ADDENDUM NO. 2

Reference: Building Consolidation – Utah State Hospital
Department of Human Services – Provo, Utah
DFCM Project No. 11065420

Subject: **Addendum No. 2**

A1 MAIN FLOOR REFLECTED CEILING PLAN

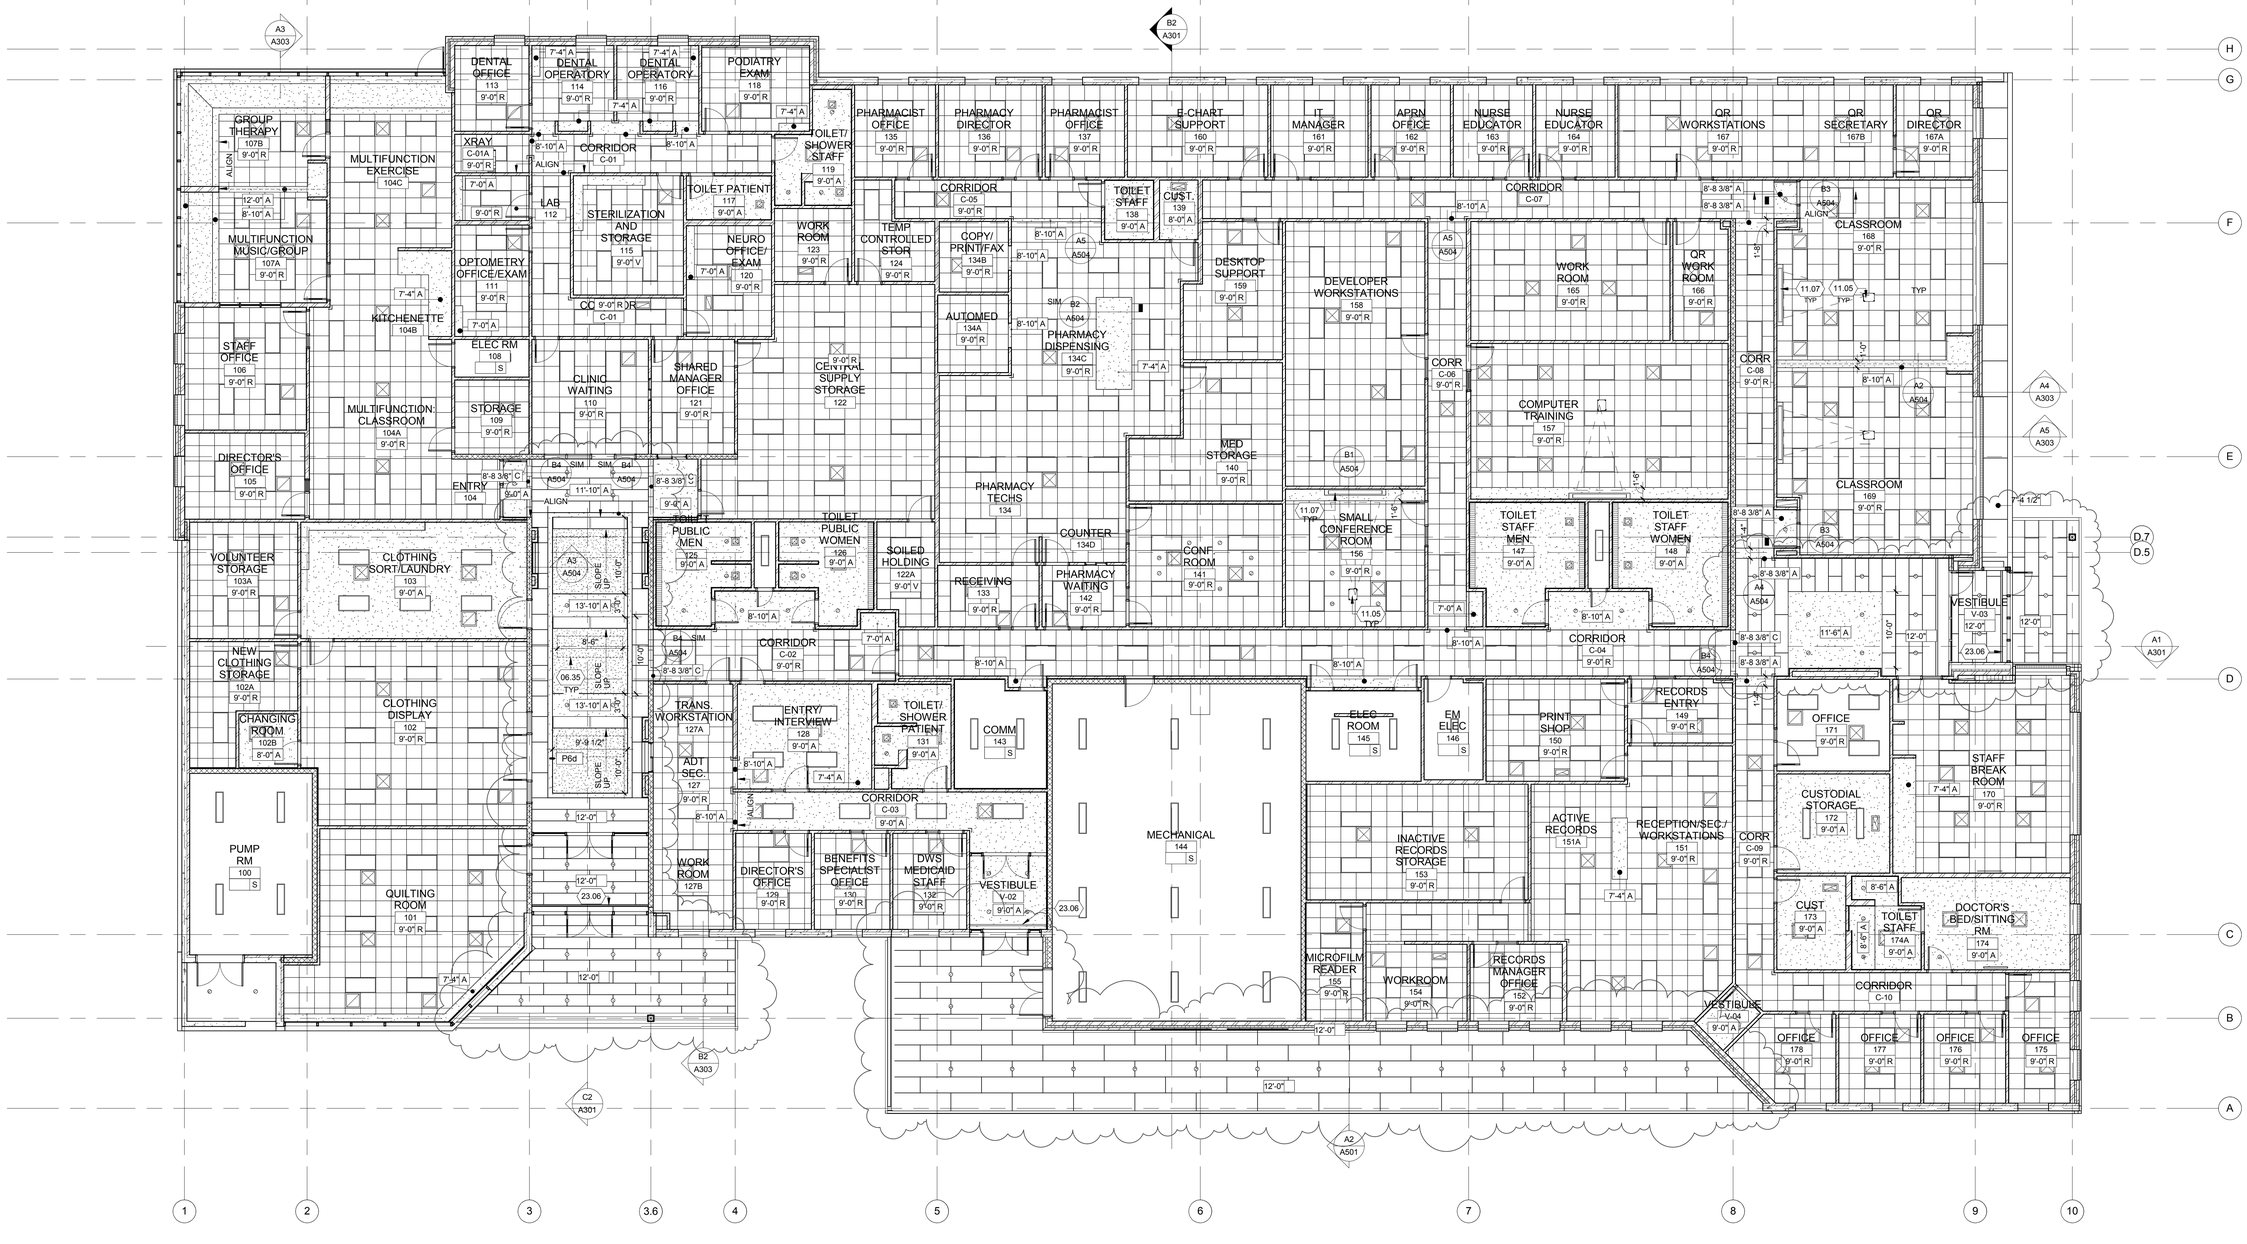
Sheet A111 - Reflected Ceiling Plan
- wood slat ceiling revised to flat veneer panels as shown
  See attached

GENERATOR ENCLOSURE - REVISED (S101B - PARTIAL)

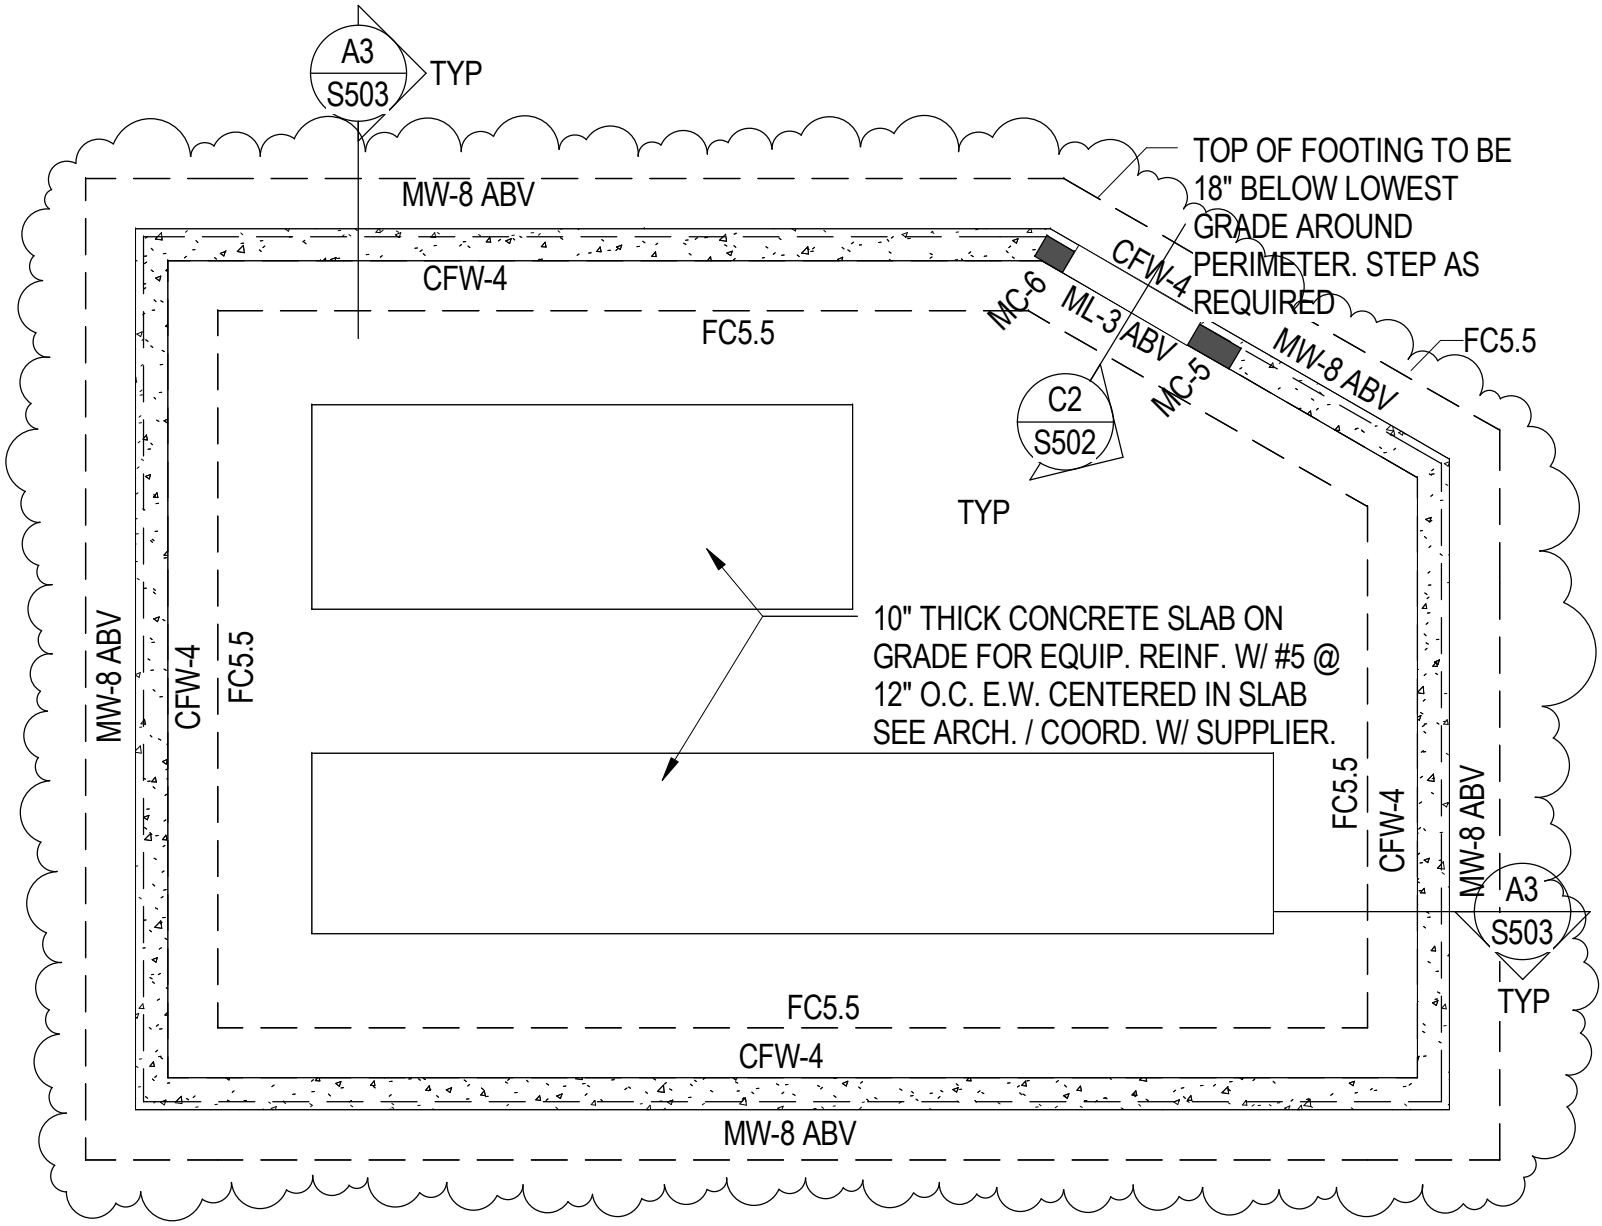
SHEET S101B
1. Revised Generator Enclosure per the attached SSD1-1.
2. Added masonry columns for openings above per SSD1-2.

1 FTH & FDTN PLAN - AREA C (PARTIAL S101C)

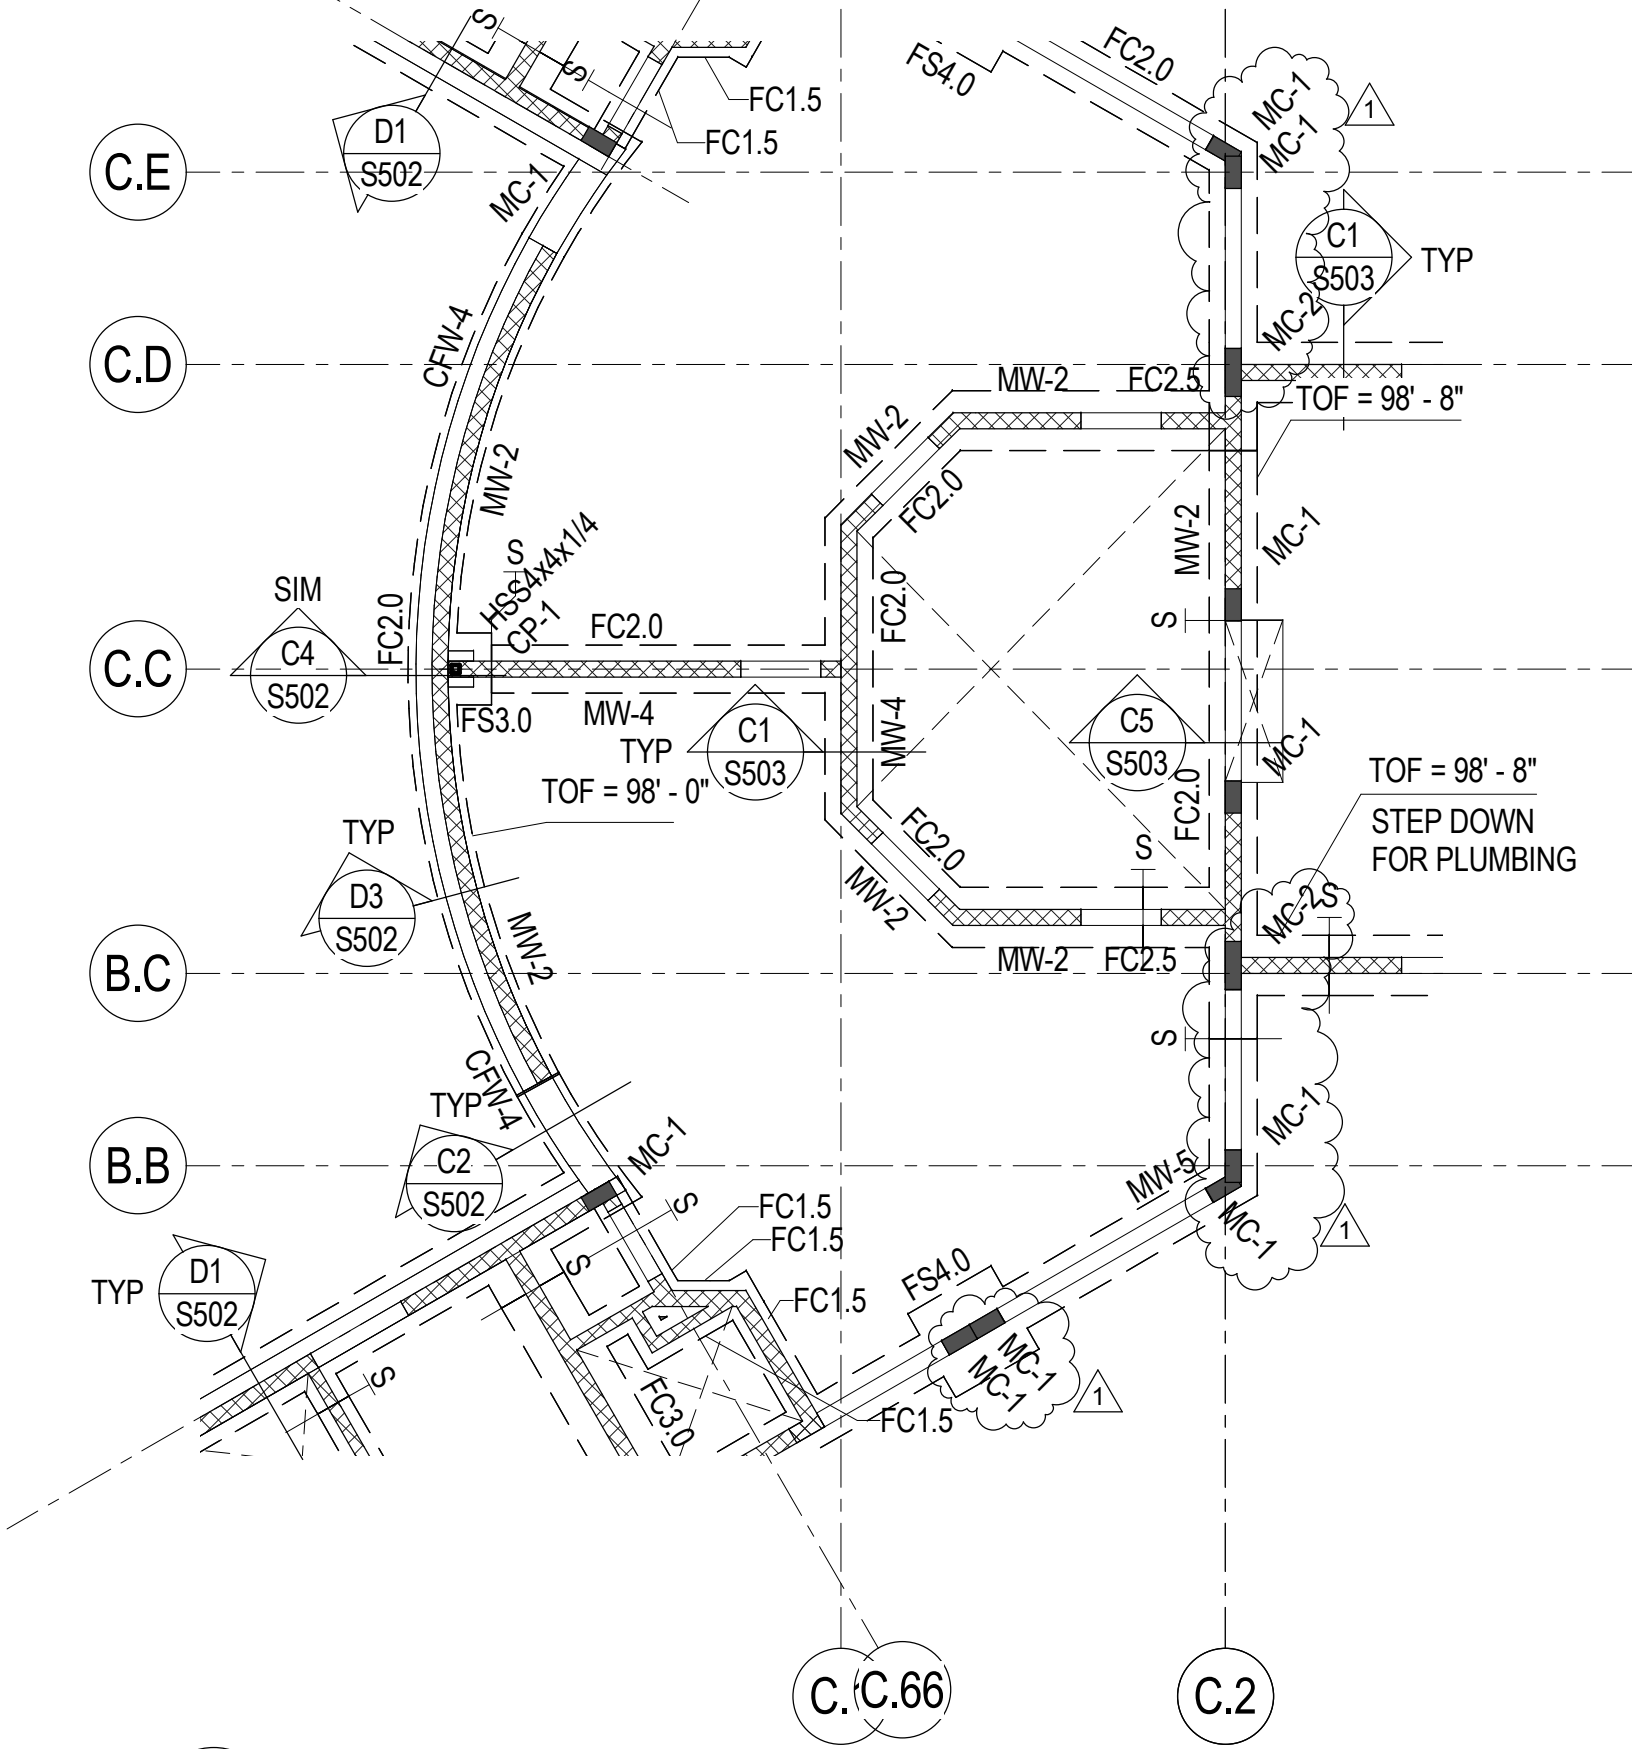
SHEET S101C
1. Revised masonry columns for openings and wall positions per SSD1-3 and SSD1-4.

FTG & FDTN PLAN - AREA D (S101D PARTIAL)

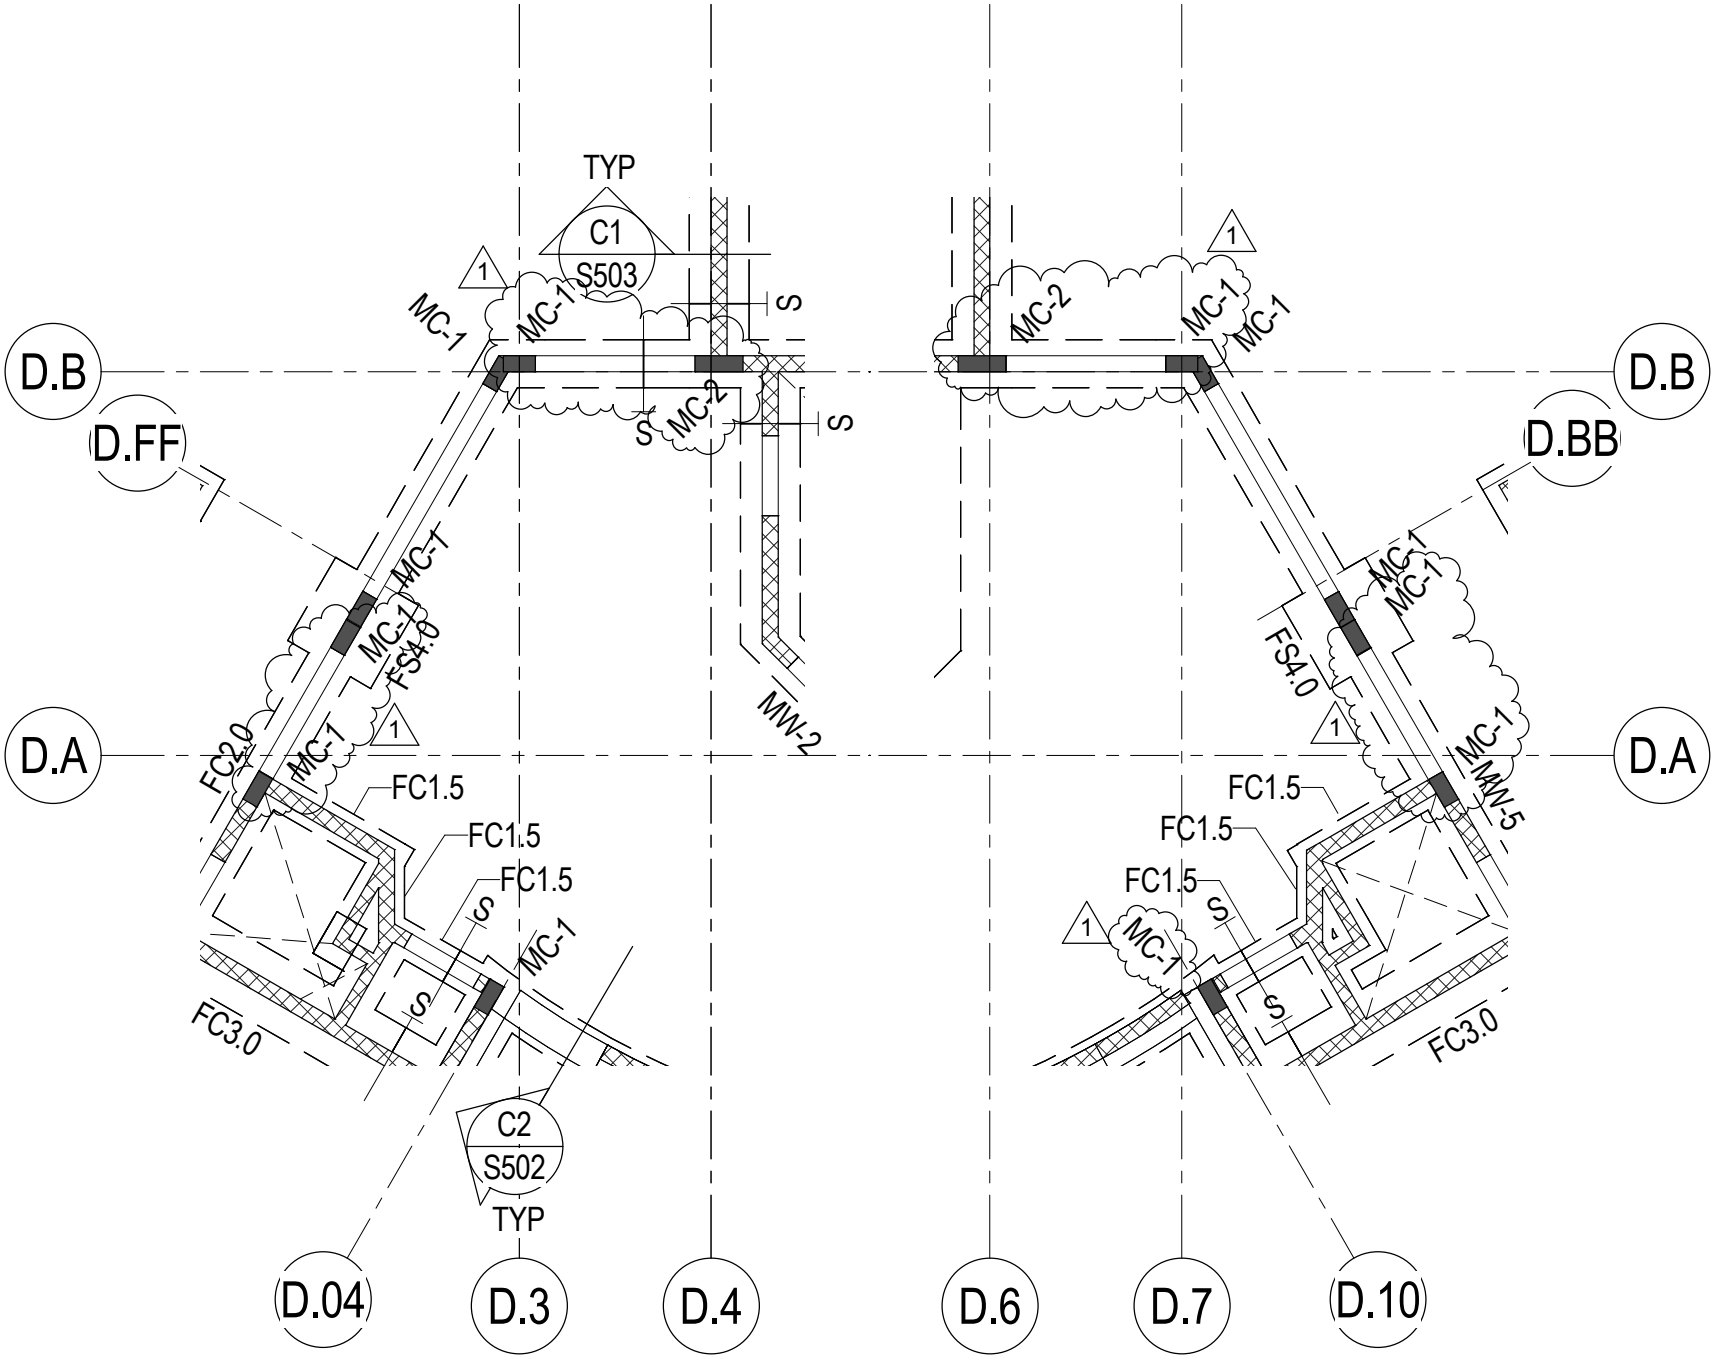
SHEET S101D
1. Revised masonry columns for openings and wall positions per SSD1-5 and SSD1-6.
